**CITY OF LA VISTA**  
**MAYOR AND CITY COUNCIL REPORT**  
**SEPTEMBER 5, 2023 AGENDA**

<b>Subject:</b>	<b>Type:</b>	<b>Submitted By:</b>
CONDITIONAL USE PERMIT – LOT 5 VAL VISTA REPLAT ONE	◆ RESOLUTIONS (2) ORDINANCE RECEIVE/FILE	CALE BRODERSEN ASSOCIATE CITY PLANNER

**CITY OF LA VISTA  
PLANNING DIVISION  
RECOMMENDATION REPORT**

SITE PLAN			REV. NO.	DATE	REVISIONS DESCRIPTION		
VAL VISTA TOMMYS							
LA VISTA, NE			2023		REVISIONS		
drawn by: ZM							
checked by: PN							
approved by: PN							
QAQC by: PN							
project no: 02206547							
date: 02.01.23

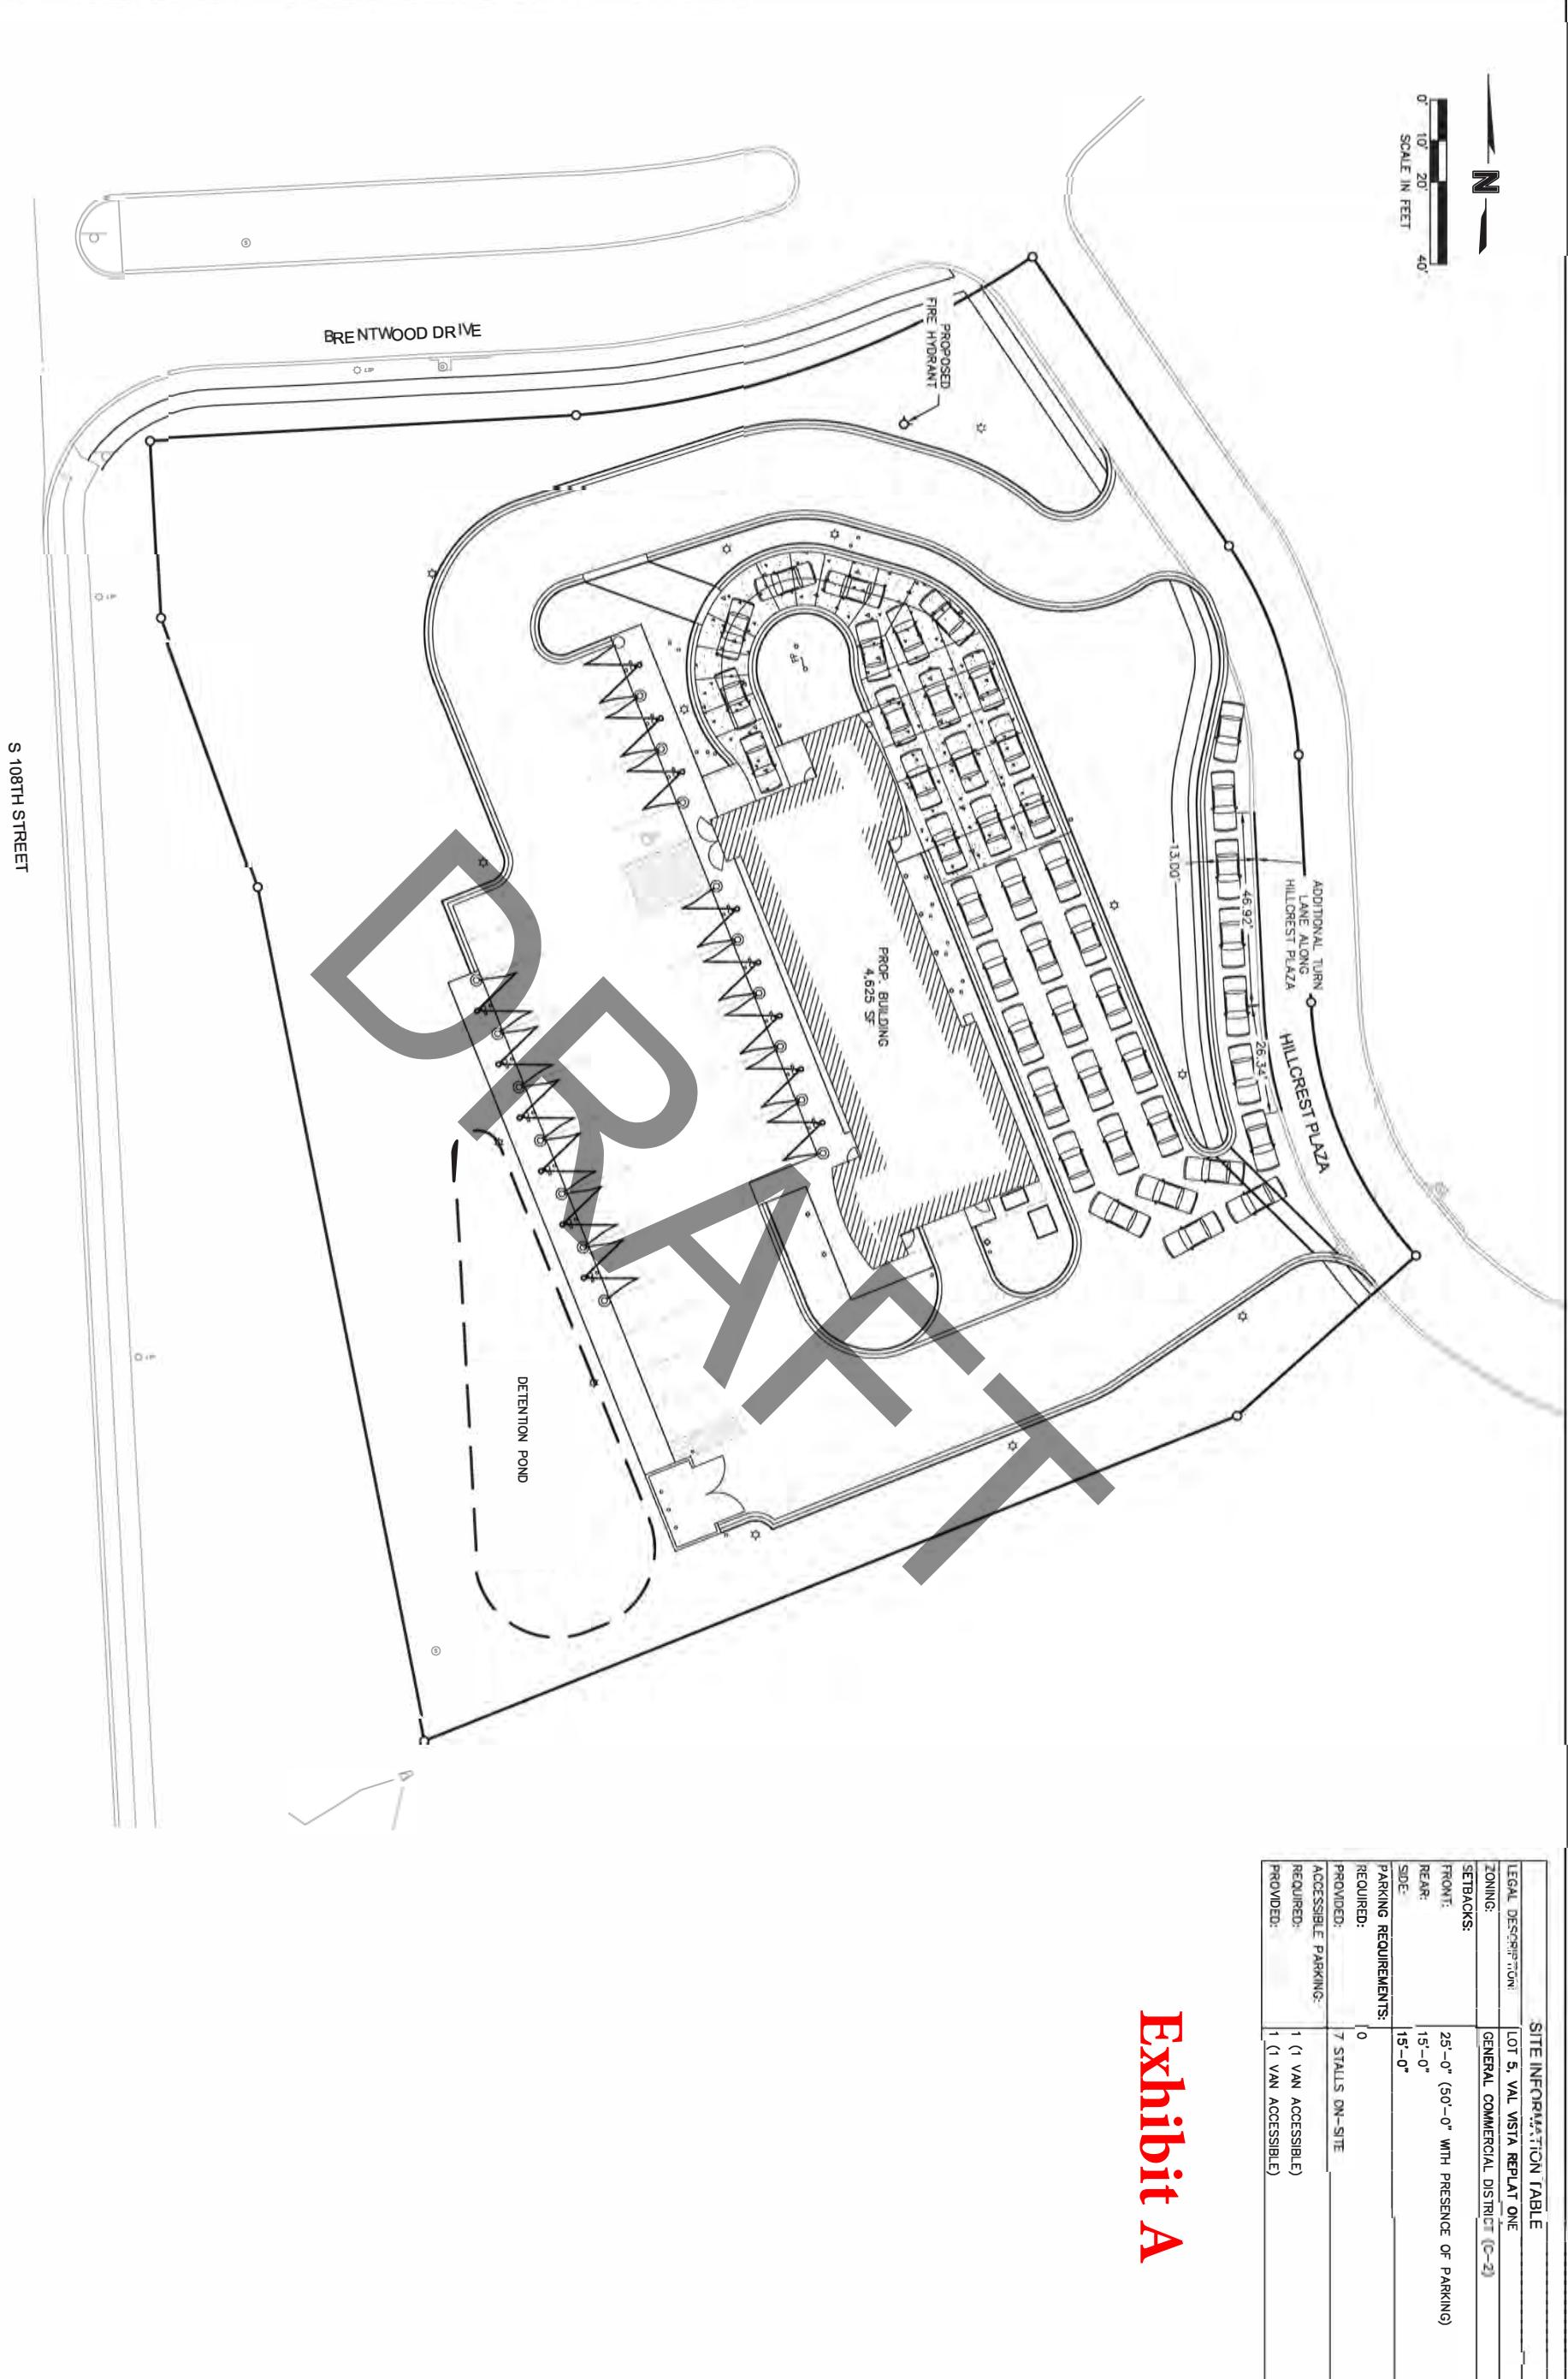
5. There are currently no fire hydrants along Hillcrest Plaza to serve this development. Private fire hydrant(s) will need to be installed. Please include hydrant locations on the site plan or on an additional exhibit.

7. Sidewalks will be required both along Brentwood Drive and Hillcrest Plaza. Please revise the site plan accordingly to represent the required sidewalks.

8. Per Section 5.11.06, the front yard setback for permitted conditional uses in the C-2 Zoning District is 25 feet, or 50 feet with the presence of parking. The "front yard" for this property includes S 108<sup>th</sup> Street, Brentwood Drive, and Hillcrest Plaza, per the definition of Front Yard depicted in the image after Section 2.07.276 of the Zoning Ordinance. It does not appear that this would cause any conflicts with your building location, however, please update the site plan to accurately reflect the proper setbacks (25 feet along Brentwood Drive, and 50 feet along 108<sup>th</sup> Street). When a property line is within a street or drive, the setback should be measured from the back-of-curb.

1. Please see attached updated operating statement
2. Please see attached updated operating statement
3. Please see attached updated operating statement
4. Please see attached updated site plan

5. Please see attached updated site plan
6. Please see attached building elevations
7. Please see attached updated site plan
8. Please see attached updated site plan

# Exhibit E

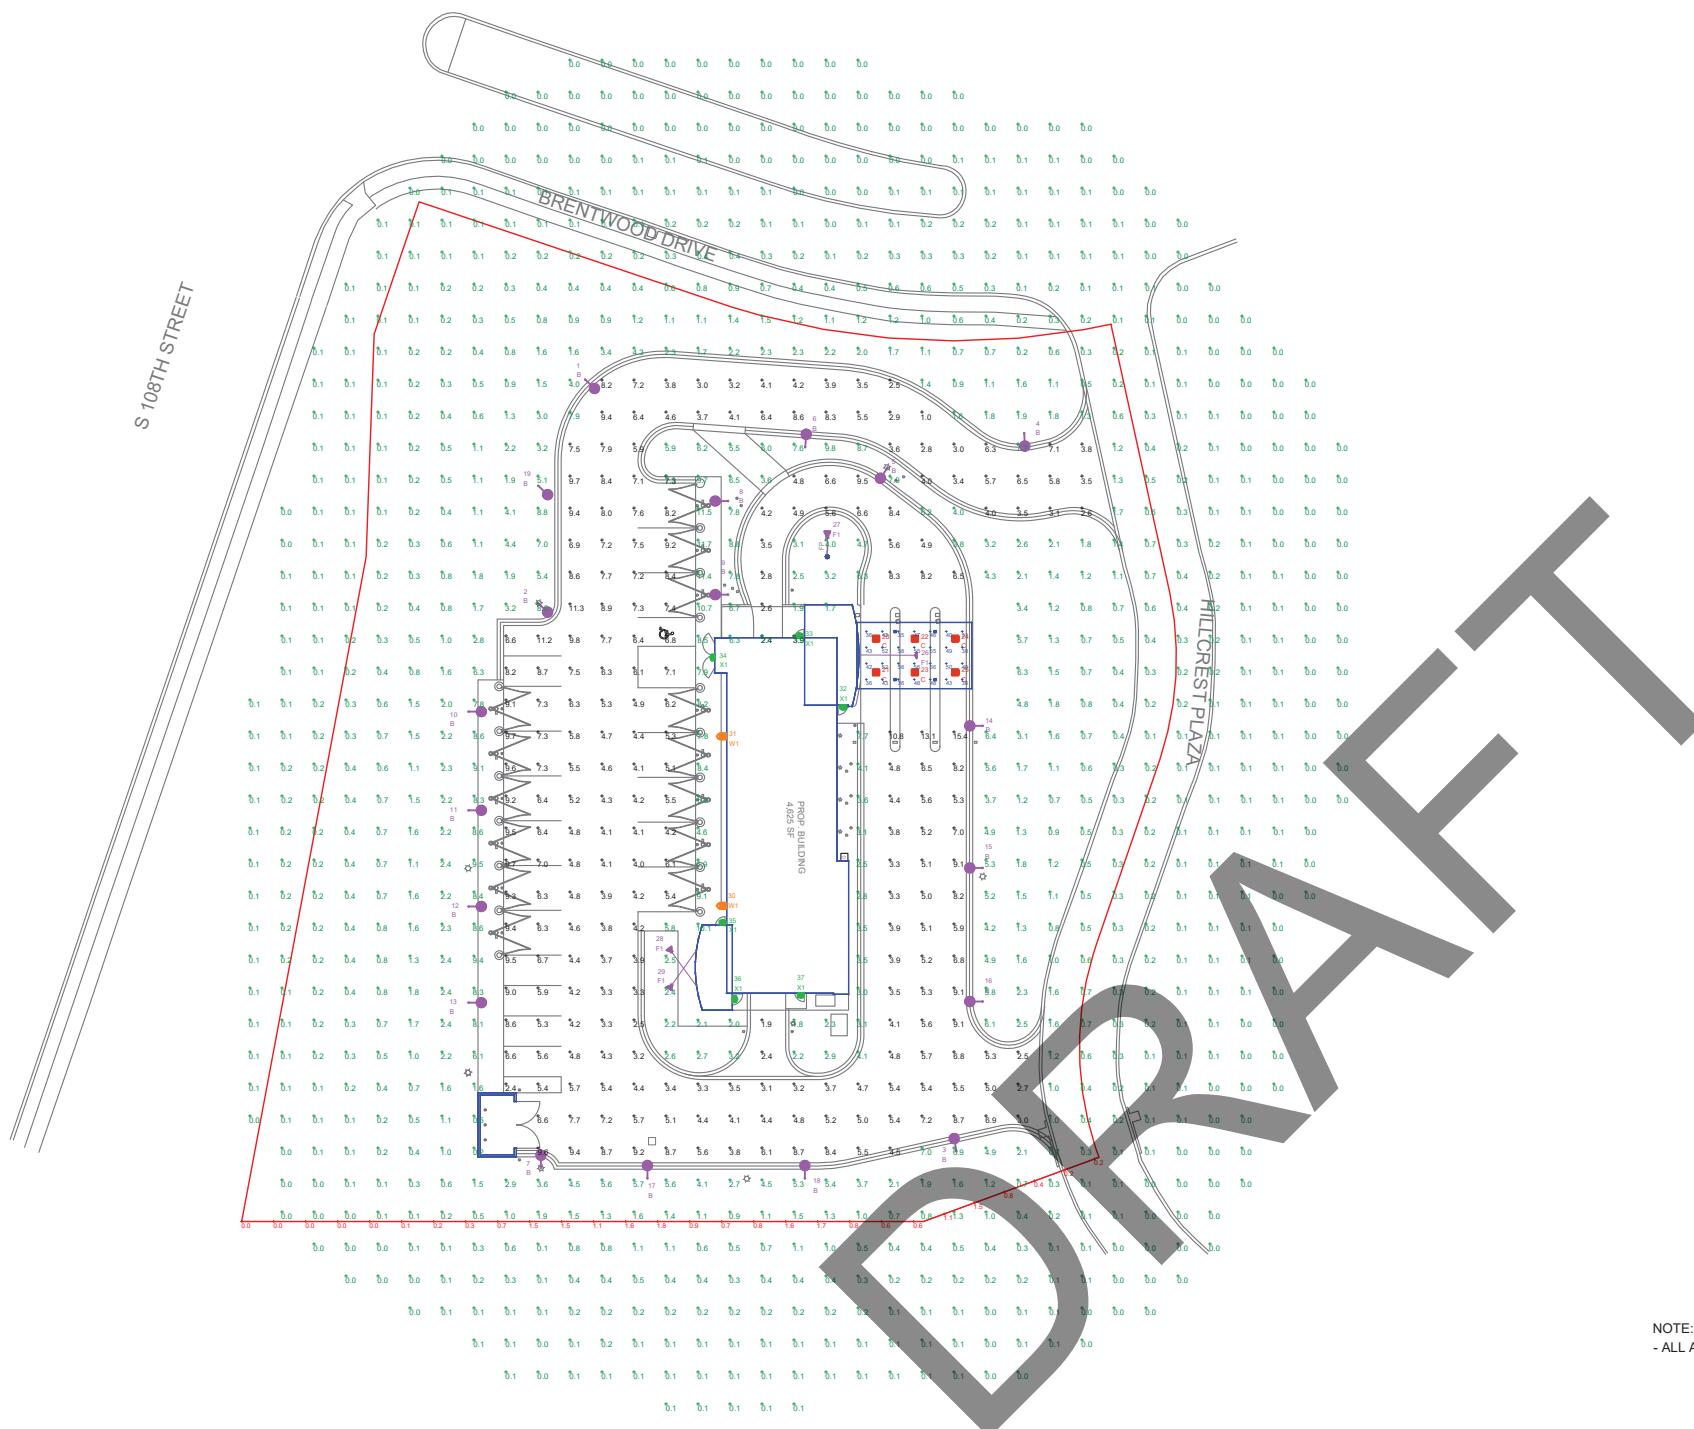
1. Pertaining to Section 6.05.04 of the La Vista Zoning Ordinance, please provide a photometric lighting plan to help us understand the lighting proposed for the site (and/or included in signage) to ensure no light trespass onto adjacent properties. Lot 6 Val Vista Replat One to the east is currently designated for medium-intensity residential development, per the 2022 Future Land Use Plan amendments, and it is imperative that any potential light pollution is avoided.

3. A photometric plan was submitted and reviewed to ensure that no significant light pollution was present on adjacent properties as per Section 6.05.09 of the Zoning Ordinance.

# Noise Map with Sound Mitigation Barrier

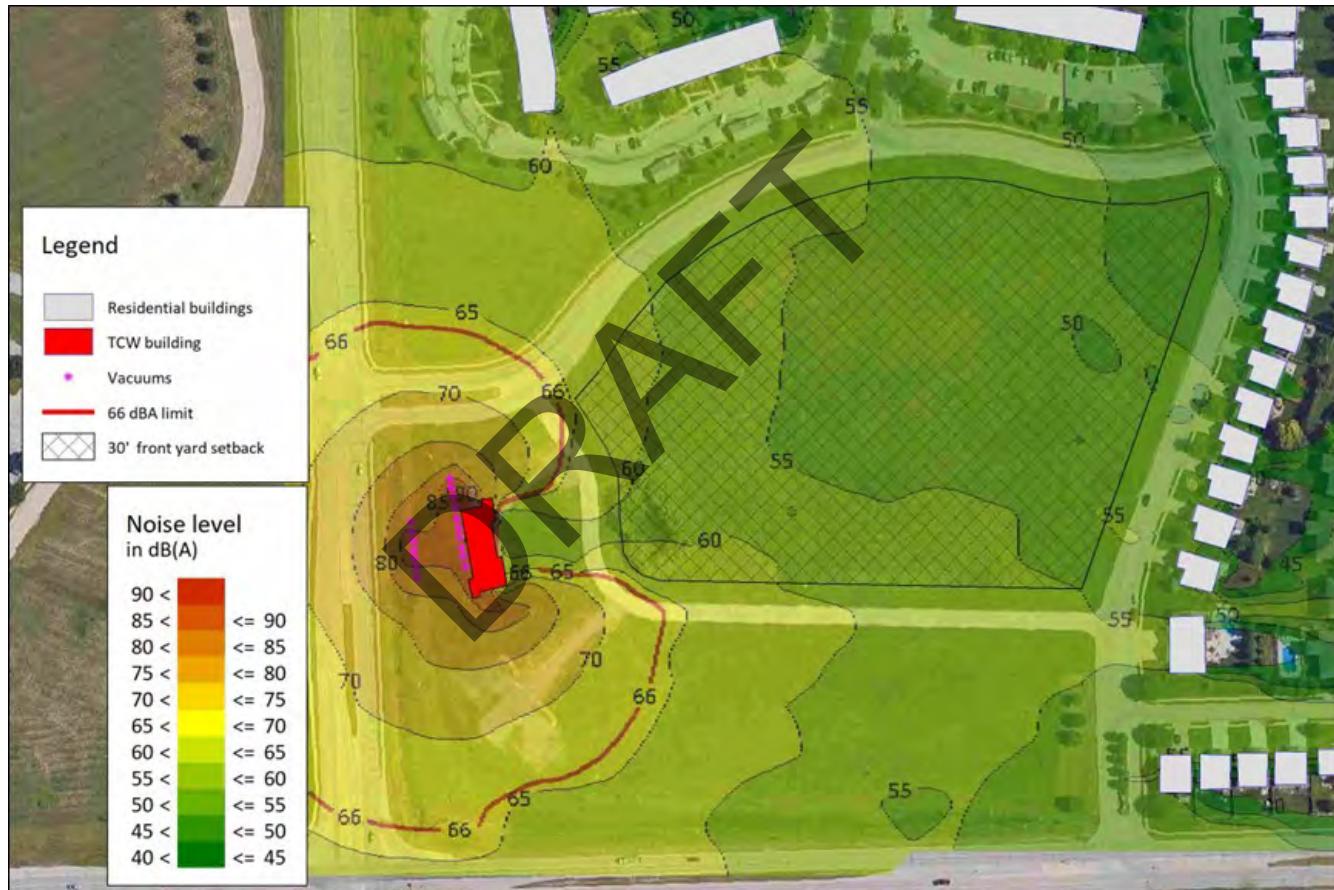
3. Pertaining to Section 6.05.06, please provide a map of the modeled existing and future noise impact that includes the subject location and surrounding properties with noise measured in terms of the hourly, A-weighted equivalent sound level in decibels (dBA).

10. The level of noise that accompanies this use as a car wash operation may be an issue for future planned residential properties to the east. The calculations for noise levels that could impact the adjacent residential buildings is above generally acceptable levels. In addition, the car wash is proposed to operate until 9:00pm.

FIGURE 10  
 VAL VISTA CAR WASH  
 LA VISTA, NEBRASKA  
 2025 RECOMMENDED GEOMETRY AND CONTROL

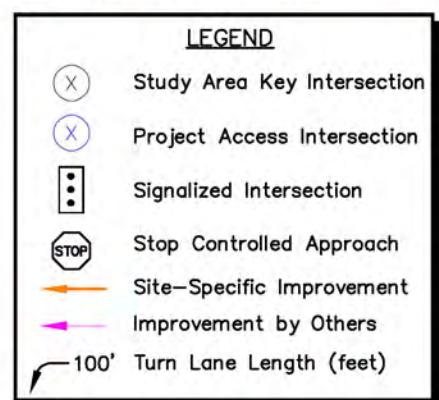
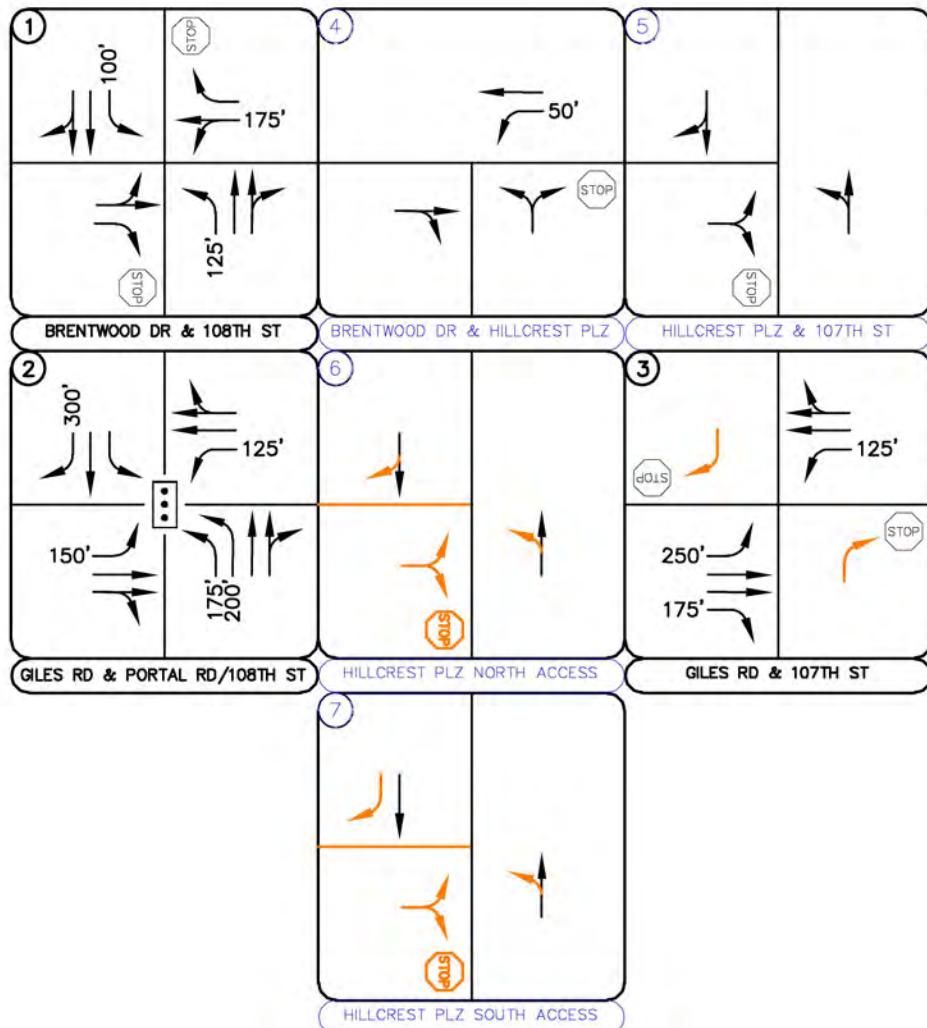
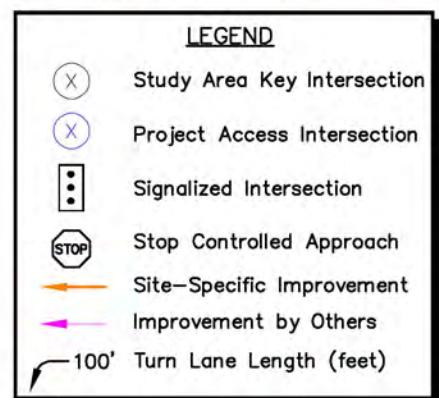
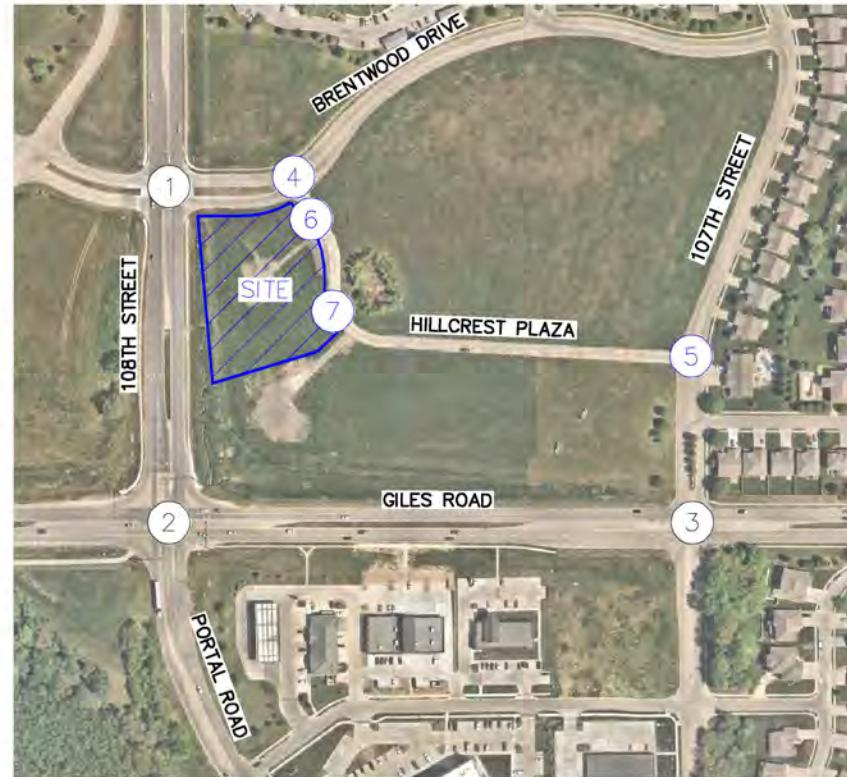
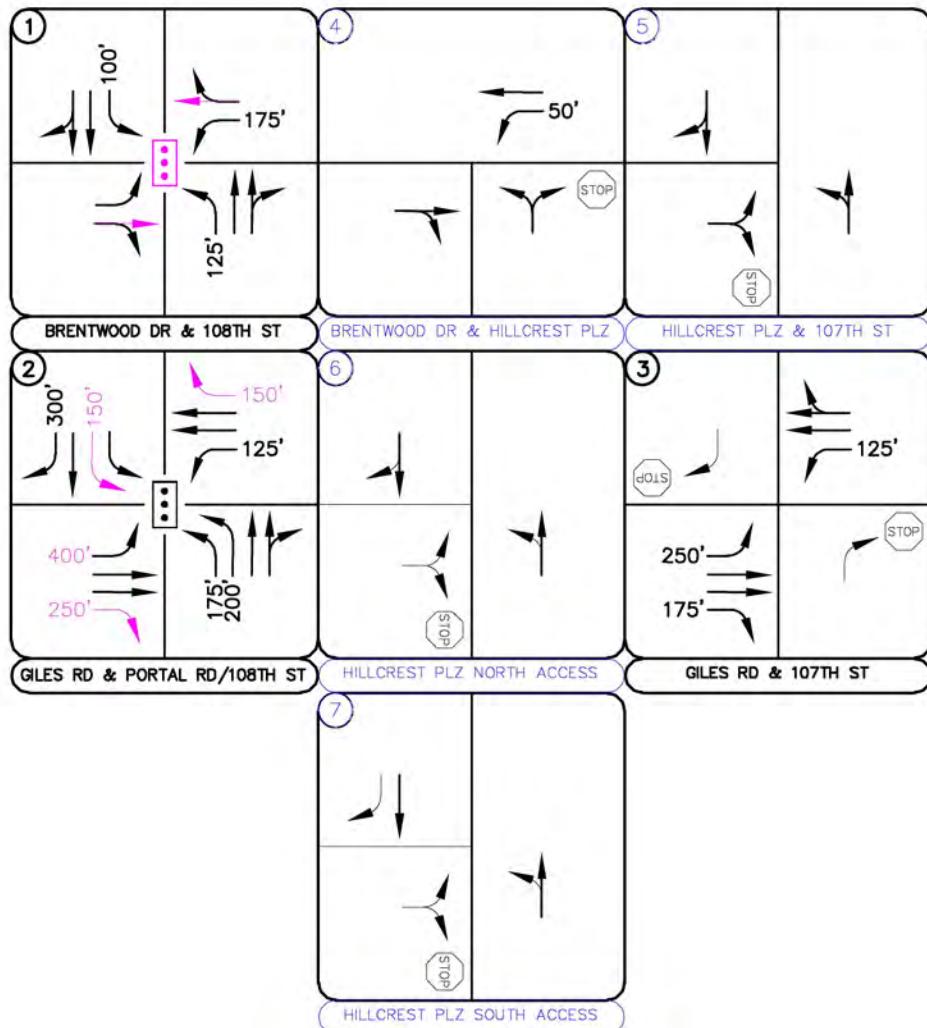
**Comment #5:** The following recommendations are based on the accuracy of the volumes collected by FHU:

**Comment #6:** Improvements at 108<sup>th</sup> Street & Brentwood Drive should be discussed between developments and City of La Vista for cost sharing.

**Response:** These recommendations were included in the revised traffic study except for the northbound right turn lane along 108<sup>th</sup> Street at Brentwood Drive or the westbound right turn lane along Giles Road at 107<sup>th</sup> Street. These turn lanes are not yet warranted. Of note, once more development is constructed on the northeast corner of Brentwood Drive and 108<sup>th</sup> Street, these turn lanes may likely be warranted.

**Response:** Agreed.
